Access Compliance Report Public Rights-of-Way (Curb Ramps)

| Intersection ID: 53380 | Main Street: IKEA_BV | Cross Street: LEWIS_ST | Location: N |
| ADA ID: CEFDC40789DF | Ramp Type: BlendTrans1 | Initial Pass/Fail: Pass | Overall Compliance: No |

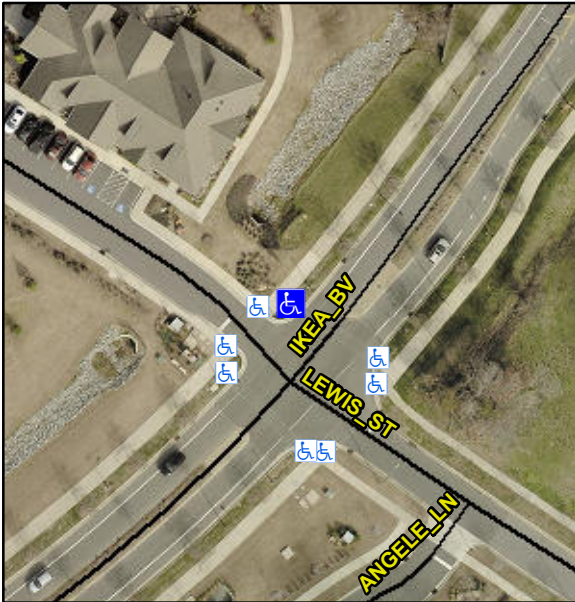
PROW/ADA:
Not Found, R302.7, R302.7.2, R304.5.3

| Compliance | Description | Data | Compliance | Description | Data |
|------------|---|-------|------------|---|------|
| No | Gutter Ponding? | Yes | Yes | Gutter Slope (%) | 4.4 |
| No | Gutter Lip Ht (in) | 0.3 | No | Gutter X Slope (%) | 3.8 |
| | | | No | Curb Slope (%) | 14.5 |

Possible Solutions:
Remove & Replace Curb Slope and Extend Ramp. Remove & Replace Gutter.
